MISSISSIPPI POWER & LIGHT COMPANY

SUBJECT: Grand Gulf Nuclear Station
Units 1 and 2
Docket Nos. 50-416 and 50-417
License No. NPF-13
File 0260/0277/L-860.0
Category I Masonry Walls
Reference AECM-82/29
AECM-83/51

AECM-83/51

Fig. I Masonry Shear and Axial Compressive Areas

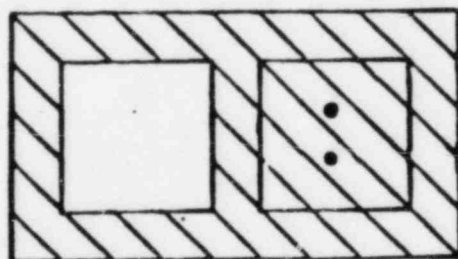
- 5.a. Provide the necessary information to justify and review the geometry of the transformed sections (cracked and uncracked) used in the analysis such as the missing dimensions on the sketches and explain their origin. Also provide explanation of the calculation of the effective areas used for axial and shear and shear alone.

Clarification of dimensions and explanation of the calculation of effective axial and shear areas are presented in Figure I.

$$= (\text{Shaded Masonry Area}) + (\text{Shaded Grout Area}) \times (\text{Modular Ratio})$$

$$= (\text{Net Masonry Area}) + (\text{Grout Area}) \times (\text{Modular Ratio})$$

FIGURE NO. 1

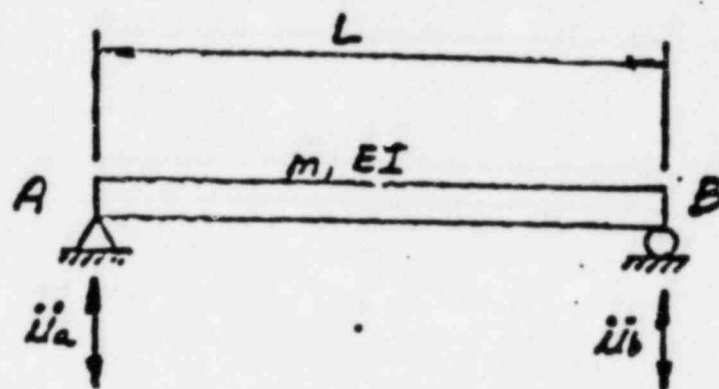
- 2.b. Paragraph 6.1.4 - Consideration of average acceleration for a wall between two floors is not in accordance with the requirements of "SEB Interim Criteria for Safety-Related masonry Wall Evaluation," July 1981, paragraph 4(d). The acceptable method of analysis is described in the SRP, Section 3.7.3.II.2.i.

Justify this apparent deviation from the Regulatory staff position and demonstrate that the conservatism of the method used in the analysis of masonry walls at Grand Gulf is comparable to that which would have been obtained if the walls between two floors were analyzed using the method stated in the SRP.

For the purposes of this evaluation, the seismic response of a simply-supported, uniform beam simulating a strip of the wall panel with unit width is considered, as shown in Figure 1.
